**SERVICE BULLETIN**

**APPLICABILITY:** 2021-22MY Impreza  
 2021-22MY Legacy / Outback  
 2021-22MY Ascent

**NUMBER:** 05-87-21  
**DATE:** 08/06/21

**SUBJECT:** Front Stabilizer Bar Bushing Clamp – Design Change

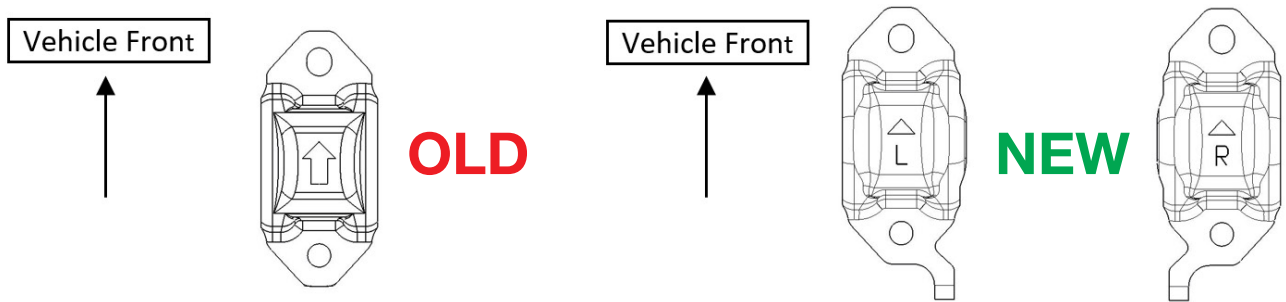
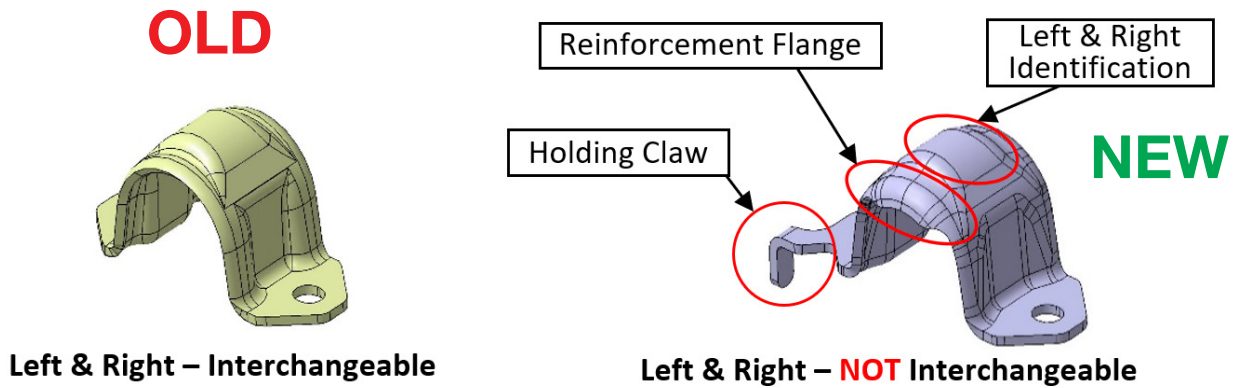
This bulletin announces a design change made to the front stabilizer bar bushing clamps. The new clamps have added reinforcement flanges with directional holding claws. They are left and right side specific and can be identified by physical (L – R) markings. Due to the new design, there will be a change to the service procedure for installing the stabilizer bar.

Part Description	Part Number
CLAMP-STABILIZER BUSHING RH	20416AN000
CLAMP-STABILIZER BUSHING LH	20416AN010

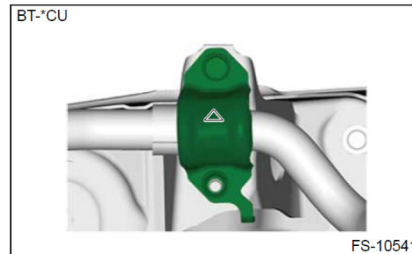
Installing the **NEW** clamps:

- Vehicles produced after the production change utilize clamp p.n.s **20416AN000** and **20416AN010**.
- Install the clamp with the peak of triangle facing the front of the vehicle.
- **REMINDER:** the shape of the clamps is different from left to right.
